DESIGN REVIEW COMMISSION AGENDA

1. Applicant: Blue Fern Management LLC
Location: 207, 211, 213 E Garden Ave, Coeur d'Alene, ID 83814
Request: Design Review approval a 15-unit townhome project called 207 Garden Townhomes with three (3) buildings on three (3) combined lots totaling 0.5 acres. The proposed project will be consolidated into one (1) legal lot. (DR-2-25)
 - Presentation by Tami Stroud, Associate Planner

FROM: TAMI STROUD, ASSOCIATE PLANNER
DATE: MAY 22, 2025
SUBJECT: DR-2-25: REQUEST FOR THE FIRST MEETING WITH THE DESIGN REVIEW COMMISSION FOR A PROPOSED 15-UNIT TOWNHOME PROJECT KNOWN AS 207 GARDEN TOWNHOMES IN THE DOWNTOWN OVERLAY NORTH (DO-N) DISTRICT R-17 (RESIDENTIAL AT 17 UNITS/ACRE) AS THE UNDERLYING ZONING DISTRICT

**F.A.R. BONUS:
COURTYARD SPACE LOOKING NORTH FROM GARDEN AVENUE FRONTAGE**

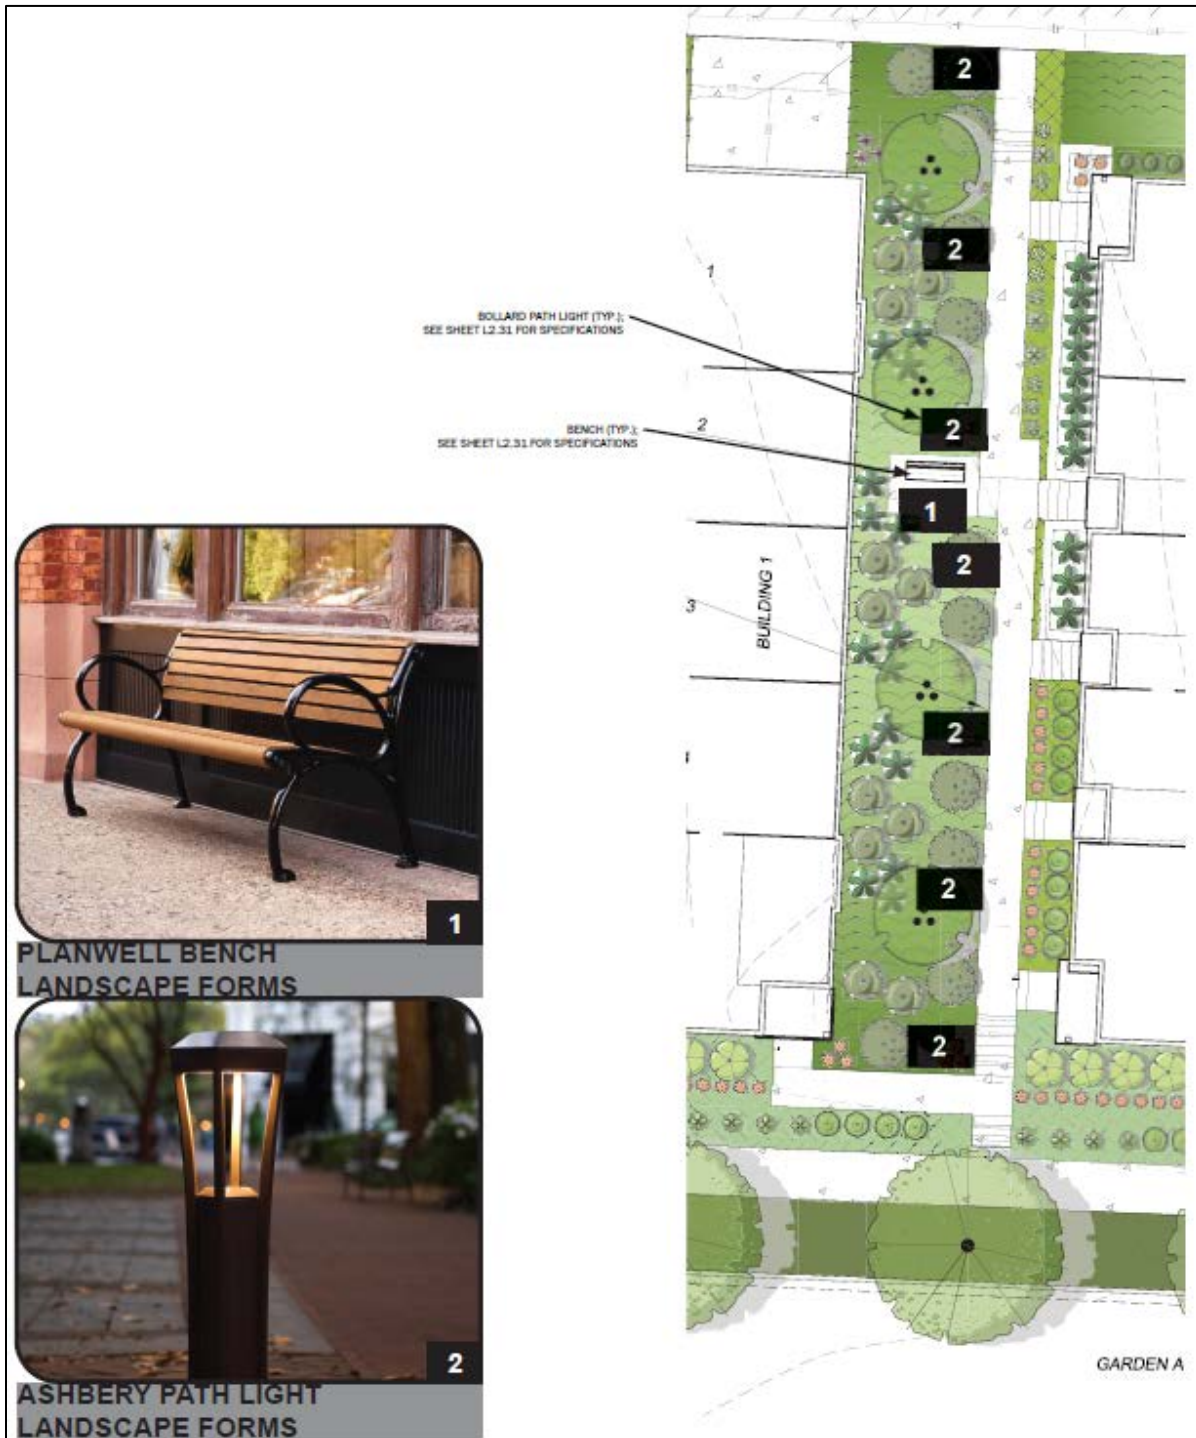
The courtyard is designed to be a landscaped passage with meandering path and quiet seating. Native landscaping with ornamental trees will provide some privacy for the units while enhancing the natural beauty of the courtyard. Adjacent entries terrace down from each fronting unit to the common space where lighting along the path and at the seating area will also be provided. Note: Blue Fern will provide a more detailed courtyard landscaping plan for staff prior to DRC.

(RE: from Hilary Patterson) Thank you for this additional level of detail and responses to my questions. This information provided me with what I needed to approve the requested FAR bonus.
